CONSTRUCTION PLANS FOR SANITARY SEWER IMPROVEMENTS IN THE PINNACLE AT CRESTVIEW

WICHITA, SEDGWICK COUNTY, KANSAS

SEDGWICK COUNTY BUREAU OF PUBLIC SERVICES
DIRECTOR: DAVID C. SPEARS, P.E.
CHANGE ORDER NO. 1
(MAIN NO. 1)
SANITARY SEWER IMPROVEMENTS
THE PINNACLE AT CRESTVIEW

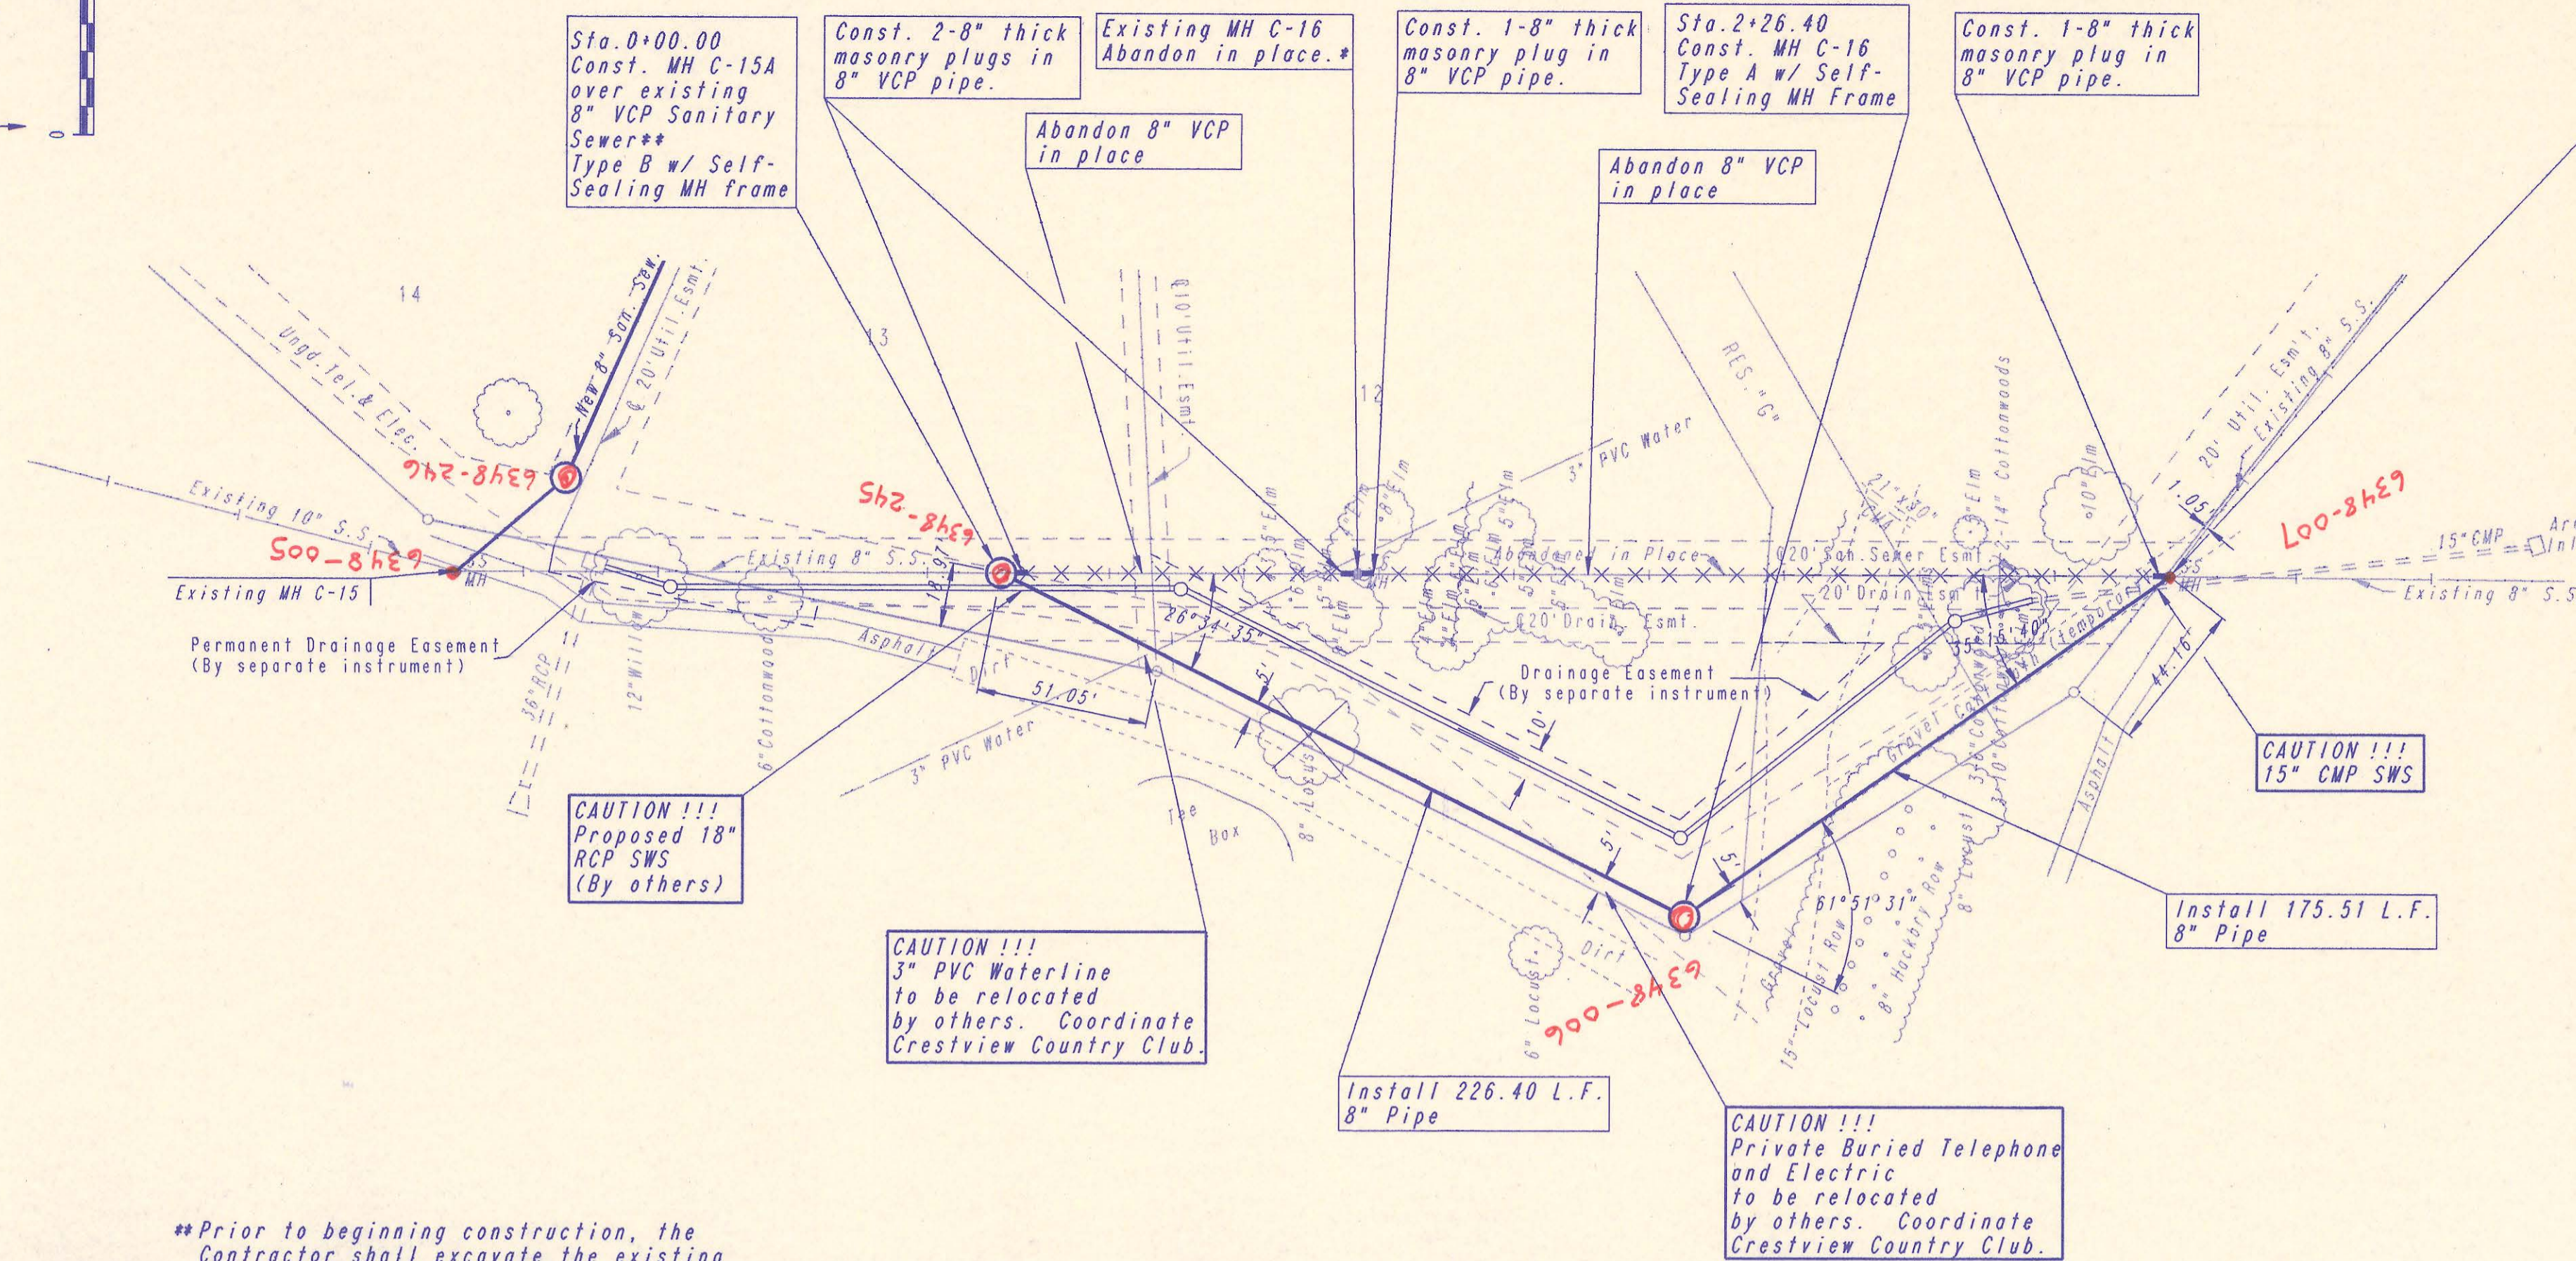
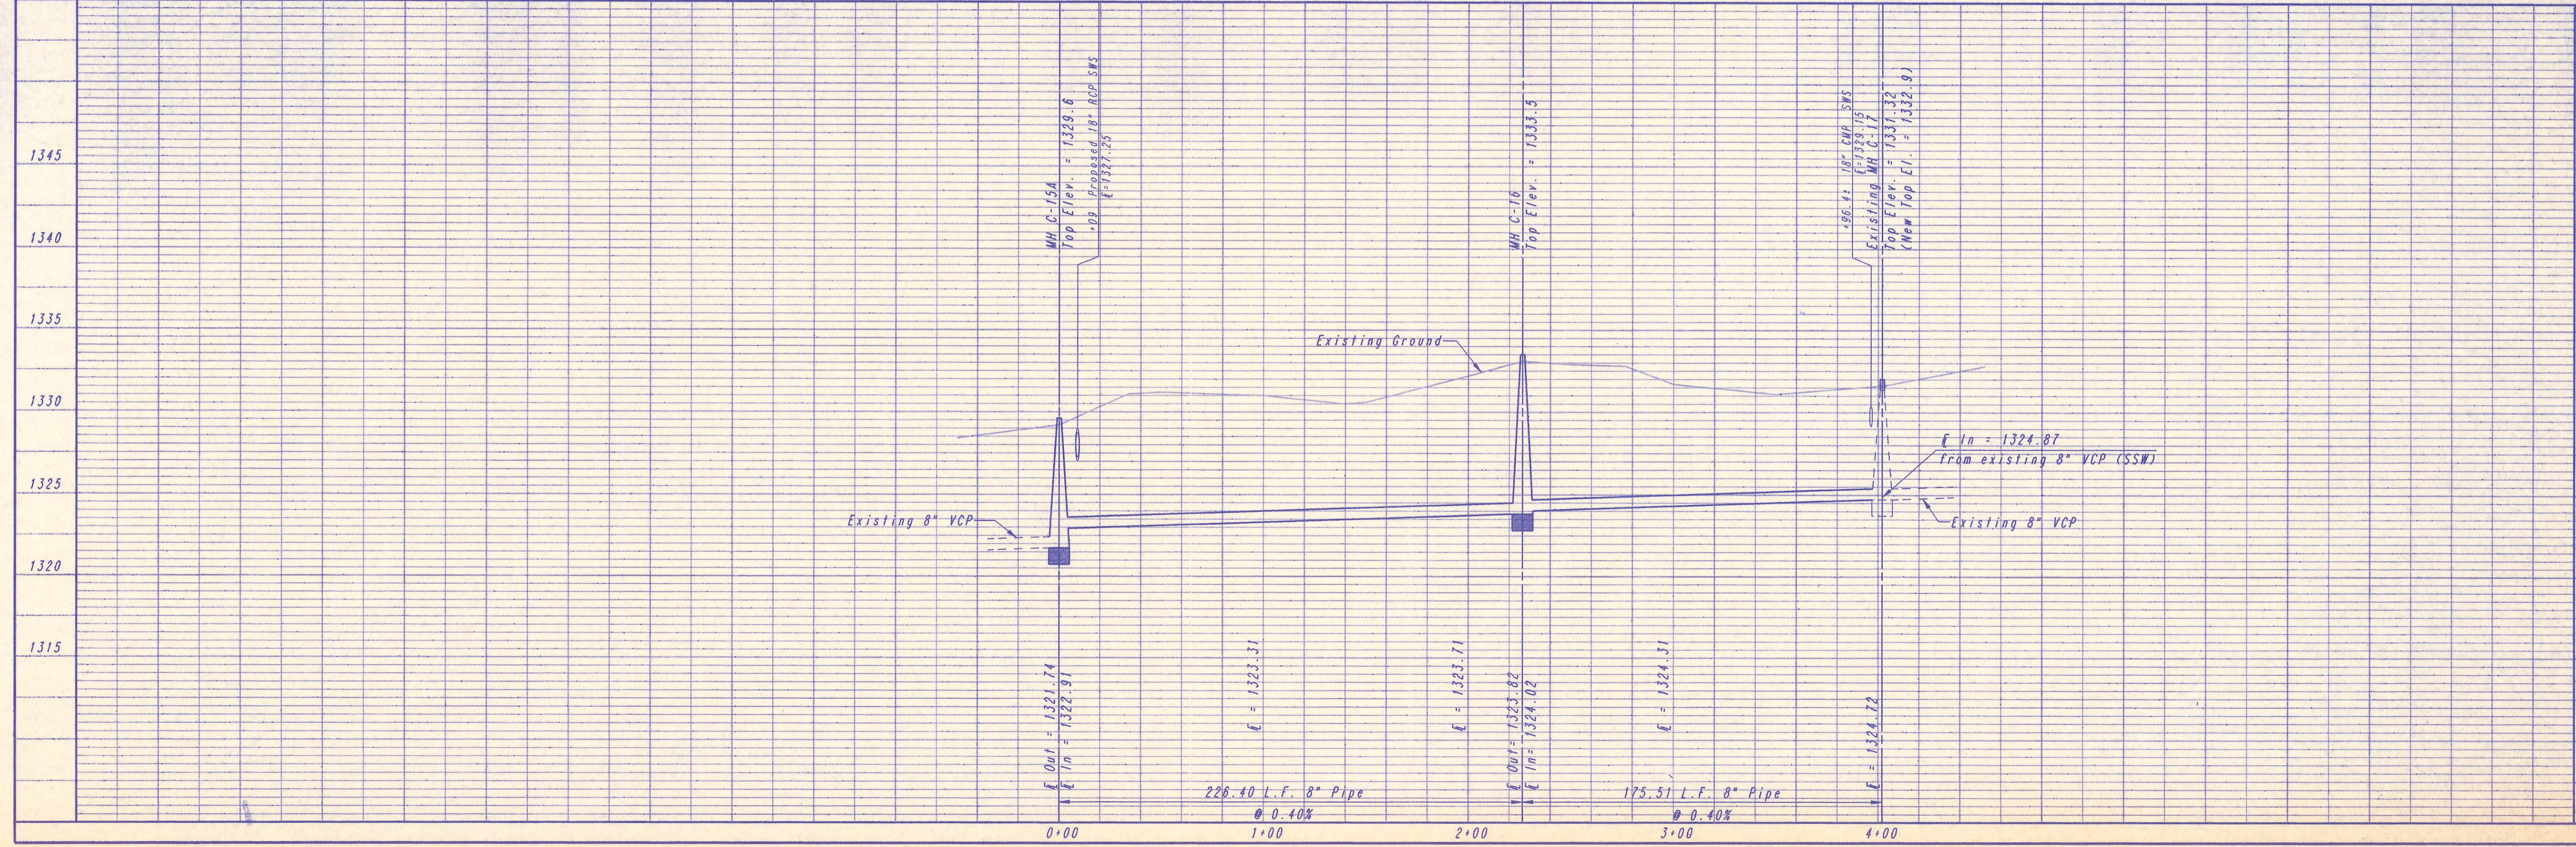
Sta. 4+01.91
Existing MH C-17
Break into existing Brick MH
and install new 8" Pipe.
Grout new pipe in place with
hydraulic cement. Reshape MH
floor to provide smooth flow.
Raise MH rim elevation
Existing rim elev. = 1331.32
Proposed rim elev. = 1332.9
Total adjustment = +1.58'
Remove exist. MH frame and
cover and replace with new
self-sealing MH frame and
cover. Coat interior of exist.
MH with Strong Seal MS 2-A
per manufacturers recommendations.
See Specifications for MH
adjustment and MH interior
coating.
All imperfections shall be filled in
with a Quick-Set Hydraulic Cement
prior to coating.

- * MH ABANDONMENT**
(The original Pinnacle at Crestview Sanitary Sewer plans called for rehabilitation of this MH (MH C-16). DO NOT PERFORM MH REHABILITATION.)
- a) Remove and dispose of MH frame and cover.
 - b) Remove top four feet (4') of the MH
 - c) Punch at least 2-1" dia. drainage holes thru MH base.
 - d) Plug all pipes in the Manhole with an 8" thick masonry plug. (2 req'd.)
 - e) Backfill remaining portion of MH with Sand. Flushed and vibrated.
 - f) Backfill of the remaining excavation shall be the same as the required for new MH construction. (Pipe plugs to be paid for separately)

**Prior to beginning construction, the Contractor shall excavate the existing 8" VCP at proposed MH C-15A. The Contractor shall verify the pipe type, elevation, and location and report his findings to the Engineer so that any necessary plan modifications may be made.
